# SCHWEIZER SERVICE BULLETIN

C1B-024.1\*  
24 Nov 2008

**SUBJECT:** THROTTLE CONTROL RESTRICTION

**MODELS AFFECTED:** 269C-1 helicopters serial numbers 0001 through 0345.

Figure C1B-024-1. Angle Tab Installation

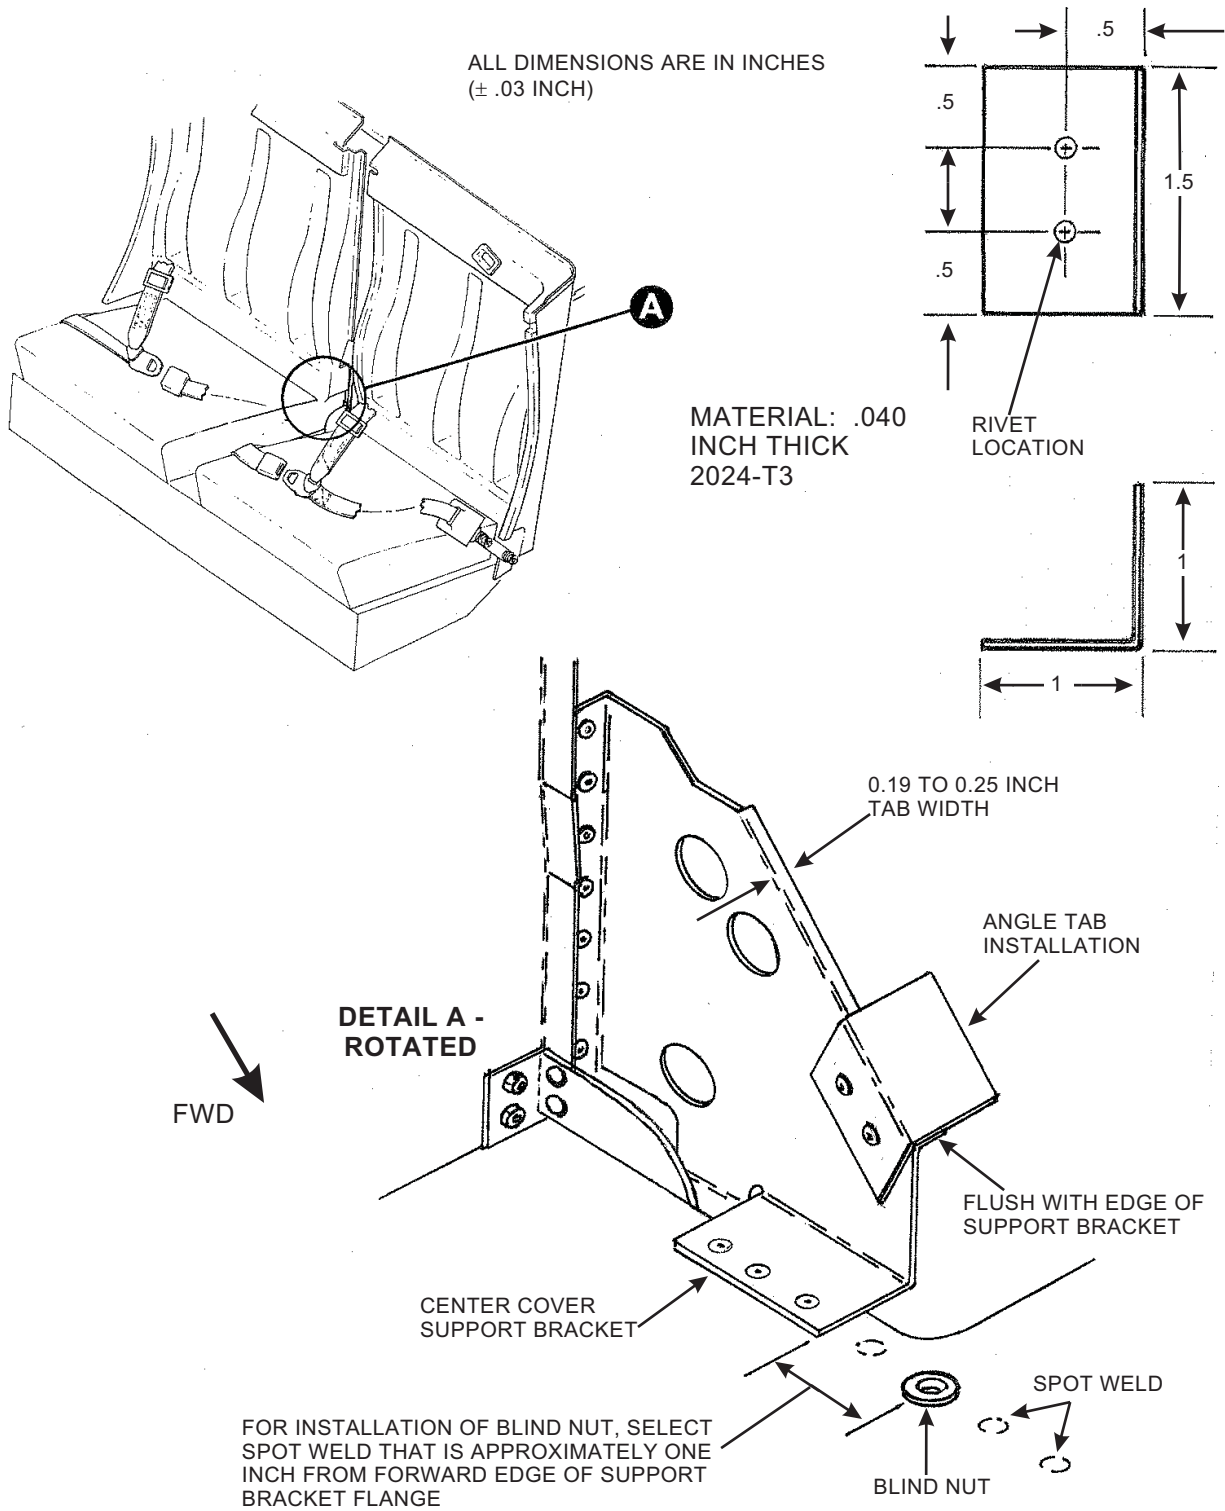
**PREFACE:** • During routine maintenance, a throttle control restriction can occur if the flight control cover in the center of the seat back is reinstalled incorrectly. Installation of a 90° angle tab on the center cover support bracket will prevent the edge of the flight control cover from being placed between the support bracket and the throttle bellcrank during cover installation. Helicopter serial numbers 0311 and subsequent have the tab installed. Also, installation of a blind nut and screw in all the affected serial numbers above will assure the cover is installed and secured in the proper position.

In the following step, helicopter serial numbers 0144 through 0310 were equipped with center cover support brackets with a top flange of 0.19 to 0.25 inch wide. Helicopters in this serial number group or any that have flanges modified to a dimension less than 0.60 inch, require installation of a 90° angle tab.

All 269C-1 model helicopters up to serial number 0319 require installation of the blind nut. The flange on the bottom edge of the center cover support bracket is riveted to the seat structure on the spot weld line of an internal longitudinal seat frame. In the next step, the blind nut will be installed in the same spot weld line.

- b. Measure flange on top edge of center cover support bracket as shown in Figure C1B-024-1. If flange is less than 0.60 inch wide, Fabricate a 90° angle tab to dimensions shown in figure. Place angle tab in position with flange flush against lower edge of support bracket. Using number 27 drill, drill two rivet holes in locations shown in figure and secure angle bracket to support bracket using CR2249-4 rivets.

- c. Select a spot weld that is approximately 1 inch forward of forward edge of bottom flange of support bracket (Fig. C1B-024-1). Drill a .250 to .256 inch hole in center of selected spot weld and make a key slot in edge of hole to accommodate key of blind nut. Install S10K80 blind nut in hole.
- d. Install and secure center flight control cover in position. Using a hole finder centered on blind nut, drill a .190 to .195 inch hole in flange of cover. Secure cover flange to seat bench with AN525-10-7 Screw and AN960KD10L Washer.
- e. Check throttle for freedom of movement and no interference.
- f. Reinstall all removed panels and seat cushions.
- g. Record compliance with this Service Bulletin in the aircraft records.

Figure C1B-024-2. Throttle Control Restriction

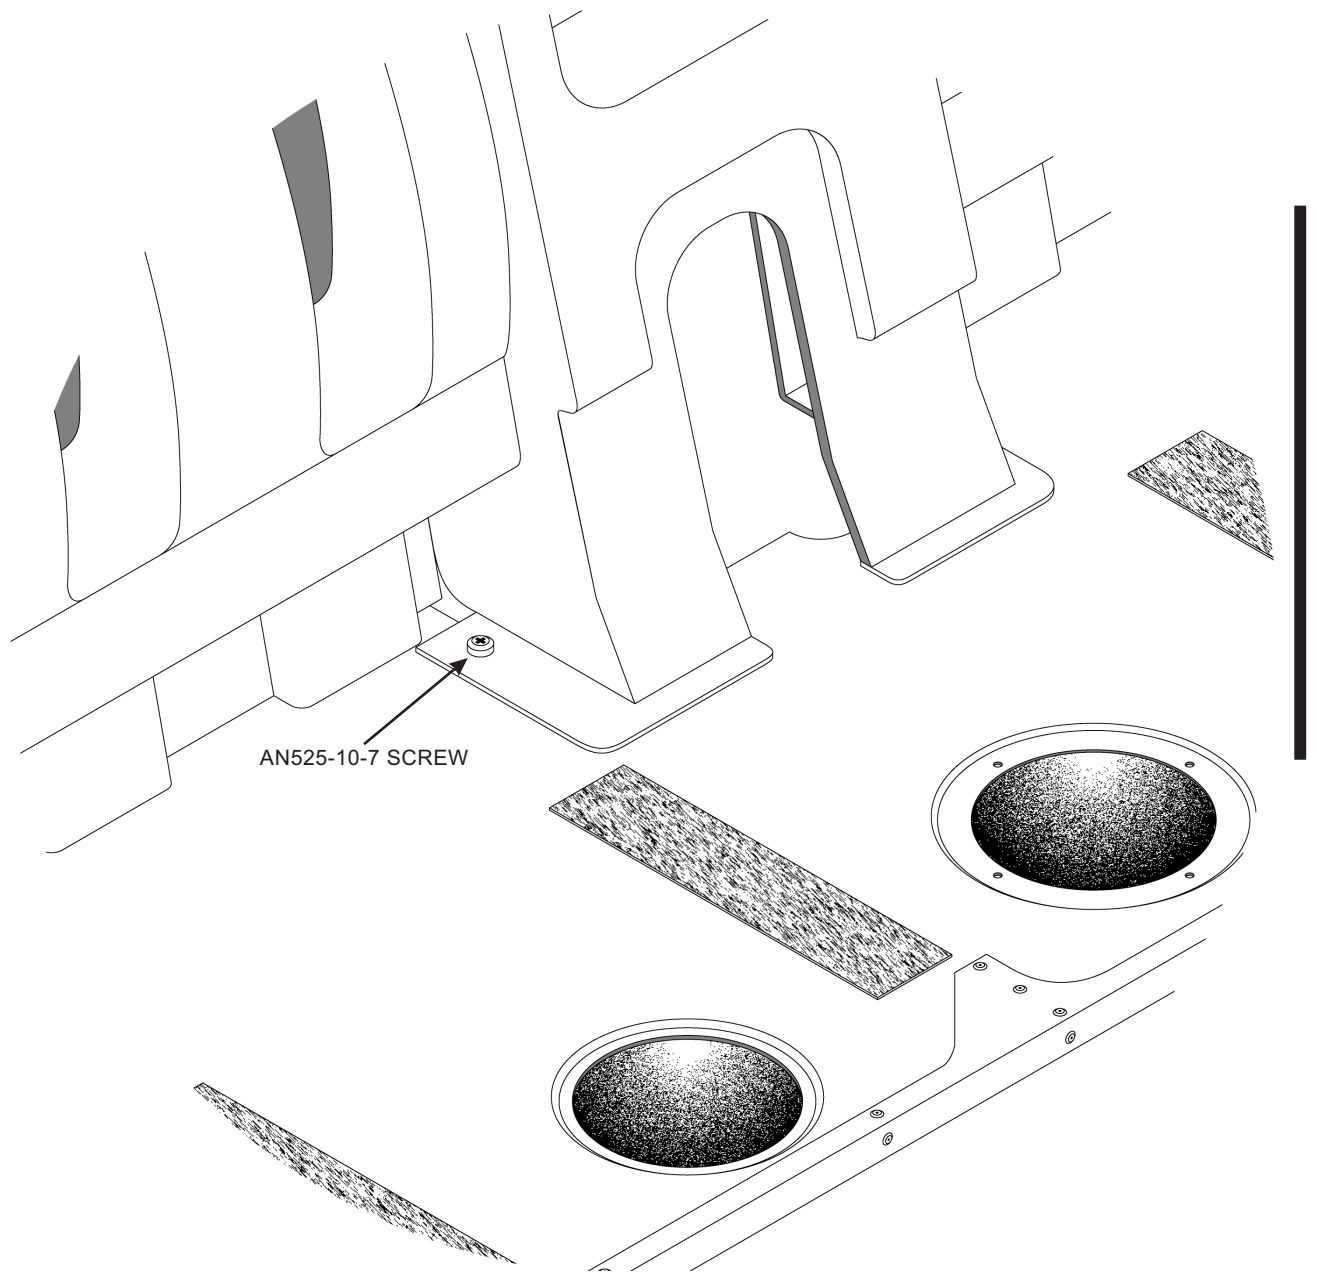
**FAILURE TO COMPLY WITH THIS SERVICE BULLETIN MAY LEAD TO A THROTTLE RESTRICTION THAT MAY SUBSEQUENTLY LEAD TO AN ENGINE AND ROTOR OVERSPEED. A ROTOR OVERSPEED THAT IS UNCONTROLLED BY THE PILOT MAY ULTIMATELY LEAD TO STRUCTURAL FAILURE OF THE ROTOR AND SUBSEQUENT SERIOUS INJURY, DEATH, AND/OR PROPERTY DAMAGE.**
